Access Compliance Report Public Rights-of-Way (Curb Ramps)

Main Street: CHIQUITA_CANYON_DR		Cross Street: AIROSO_ST		Location:	S
ADA ID: RPRK211124131300	Ramp Type:Type 1 - Perpendicular	Initial Pass/Fail: Fail	Overall Compliance: No	Severity Score:	2
Codes/Mitigation Info/Possible Solution			Field Measurements/Component Compliance

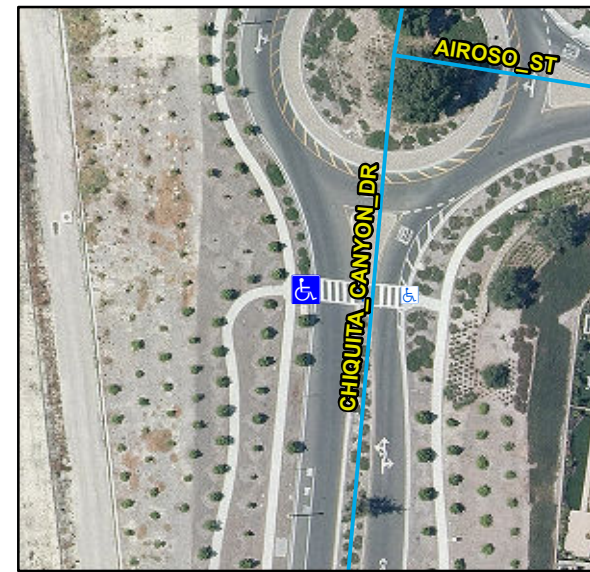
Compliance	Description	Data	Compliance	Description	Data
N/A	Ramp Length (in)	102	N/A	Flare Type LT	
Yes	Ramp Width (in)	60			N/A
Yes	Ramp Run Slope (%)	5.1	N/A	Flare Slope LT (%)	N/A
No	Ramp Cross Slope (%)	3.8	N/A	Flare Traversable LT	N/A
N/A	Landing Present	N/A	N/A	Flare Type RT	
N/A	Landing Length (in)	N/A			N/A
N/A	Landing Width (in)	N/A	N/A	Flare Slope RT (%)	N/A
N/A	Landing Run Slope (%)	N/A	N/A	Flare Traversable RT	N/A
N/A	Landing Cross Slope (%)	N/A	N/A	DWS Provided	N/A
N/A	Landing Movement Obstructed?	N/A	N/A	DWS Contrast	N/A
	Landing Movement Type	N/A	N/A	DWS Length (in)	N/A
N/A	Landing Shared	N/A	N/A	DWS Full Width	N/A
N/A	Clear Space	N/A	N/A	DWS Offset Left (in)	N/A
N/A	Clear Space To Crosswalk (in)	N/A	N/A	DWS Offset Right (in)	N/A
N/A	Marked Crosswalk 1	Yes	N/A	Marked Crosswalk 2	N/A
	Crossing 1 Direction	E		Crossing 2 Direction	N/A
	Marked Crosswalk 1 Width (in)	144		Marked Crosswalk 2 Width (in)	N/A

N/A	Ramp Inside Crosswalk 1	Yes	Yes	Ramp Inside Crosswalk 2	N/A
	Crossing 1 Slope (%)	0.5		Crossing 2 Slope (%)	N/A
	Crossing 1 Cross Slope (%)	3		Crossing 2 Cross Slope (%)	N/A
N/A	Gutter Ponding	N/A	No	Curb Slope	6.7
Yes	Gutter Lip Height (in)	0		Road Run Slope (%)	N/A
N/A	Gutter Run Slope (%)	N/A		Road Cross Slope (%)	N/A
N/A	Gutter Cross Slope (%)	N/A			
Yes	Overall Surface Condition: Acceptable		Yes	Perp Joint Present	Yes
	Cross Gutter Present?	No		Spandrel Present?	No
	Replace Cross Gutter?	N/A		Replace Spandrel?	N/A

Remove & Replace Entire Ramp.
